REMARKS

Record of Personal Interview under 37 C.F.R. § 1.133(b).

Claims 113-117

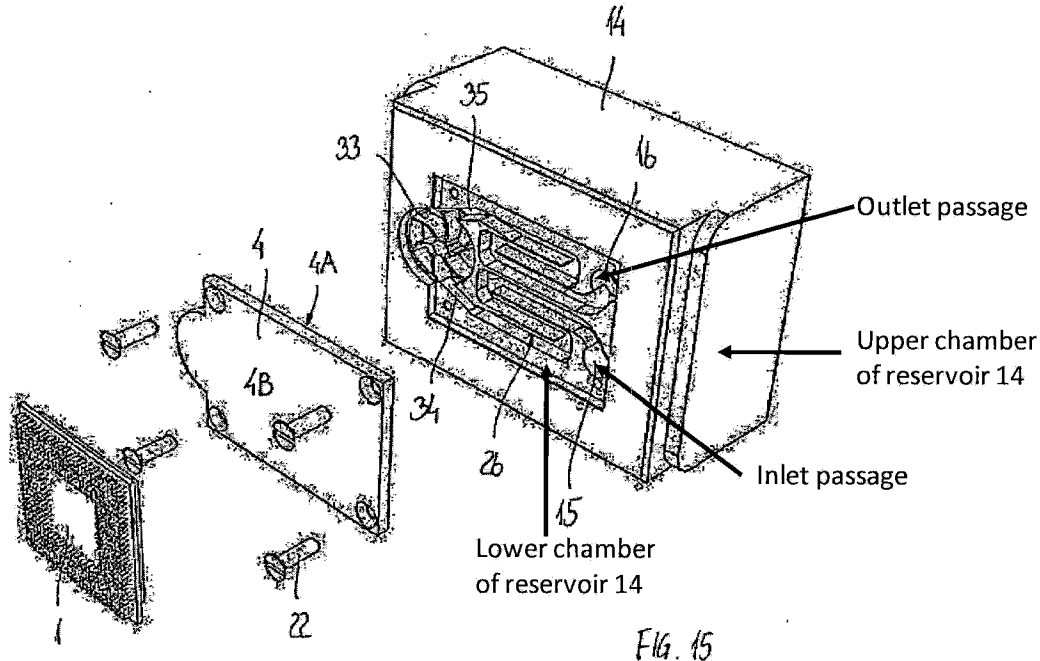
In the Office Action, claims 74, 88, and 113-117 were rejected as failing to comply with written description requirement of § 112, because the limitations of these claims are not supported in the originally filed disclosure. Office Action, pg. 3-4.

Although claims 113 and 117 have been cancelled by this response, the limitations of claim 113 have been included in independent claim 70 and the limitations of claim 117 have been included in independent claim 103. Claims 114-116 depend from amended independent claim 70. As agreed by the Examiner during the interview, at least FIGS. 15 and 16 in the originally filed drawings illustrate the claimed features of these claims. Applicant submits that the written description in the specification (see, for instance, ¶¶ 127-129) would also clearly convey to one of ordinary skill in the art, that Applicant possessed a cooling system with the features recited in these claims. For instance, FIG. 15 of the originally filed application (annotated and reproduced below) identifies the relevant features of these claims.

“To satisfy the written description requirement, the disclosure of the specification must “convey with reasonable clarity to those skilled in the art that, as of the filing date sought, [the inventor] was in possession of the invention.” *Revolution Eyewear, Inc. v. Aspex Eyewear, Inc.*, 563 F.3d 1358, 1366 (Fed. Cir. 2009). If a skilled artisan would have understood the inventor to be in possession of the claimed invention at the time of filing, even if every nuance of the claims is not explicitly described in the specification, then the adequate description requirement is met. *Vas-Cath Inc. v. Mahurkar*, 935 F.2d 1555, 1563 (Fed.Cir. 1991). Applicant submits that, based on the originally filed specification, a skilled artisan would have clearly understood the inventor to be in possession of a cooling system with the features claimed in claims 113-117. Accordingly, Applicant respectfully requests that the § 112 rejection be withdrawn.

FIG. 1

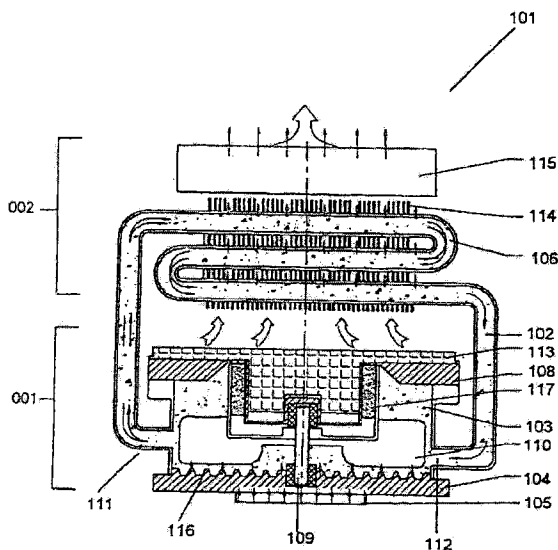
In the Office Action, Wu was relied upon for these teachings. Office Action, pgs. 4-5. With reference to FIGS. 1 and 5 of Wu reproduced above, Wu discloses a cooling system (101) in which an absorption section (001) is fluidly coupled to a radiation section (002) with conduits

(106) circulating a coolant (102) therebetween. ¶ 0016. The absorption section (001) of Wu includes a coolant storage unit (103) enclosed using an absorption layer 104 at the bottom and a top cover (108) (see FIG 4) at the top. *Id.* An impeller (110) is centrally positioned in the absorption layer. *Id.* The motor of Wu includes the impeller (110) and a rotor (117) placed inside the coolant storage unit (103), and a stator (113) positioned outside the coolant storage unit (103) and atop the top cover (108). See, end of ¶ [0020] on pg. 2.

In the Office Action, coolant storage unit (103) of Wu is interpreted as the recited reservoir with a region above the top cover (108) as the recited “upper chamber” and the region below the top cover (108) as the recited “lower chamber” having a “recessed cavity.” See Office Action, pgs. 4 and 5. Applicant submits that the region above the top cover (108) is outside the coolant storage unit (103) and is not a part of the coolant storage unit (103) as interpreted by the Examiner. Therefore, Wu’s coolant storage unit (103) includes only one chamber and does not include an upper chamber and a separate lower chamber as required by amended independent claim 103. Further, even if the region outside the coolant storage unit (103) were considered as the recited upper chamber, in Wu, the upper and the lower chambers are not “separate chambers that are fluidly coupled together by an inlet passage and an outlet passage, the inlet passage being a passage that directs the cooling liquid from the upper chamber to the lower chamber and the outlet passage being a passage that directs the cooling liquid from the lower chamber to the upper chamber,” as recited in amended independent claim 103. Further, Applicant submits that the coolant storage unit (103) of Wu does not include a “recessed cavity” with the “impeller [] positioned in the recessed cavity,” as also recited in independent claim 103. Wu also does not suggest these aspects of amended independent claim 103. Therefore, Wu does not disclose or suggest at least these aspects of amended independent claim 103. Scott and Getkin do not

remedy the deficiencies of Wu. Therefore, amended independent claim 103 is allowable over Wu, Scott, and Getkin. Claims 106 and 107 depend from amended independent claim 103 and include all of its limitations. Therefore, these dependent claims are allowable over the cited references at least for the same reason that amended independent claim 103 is allowable over these references.
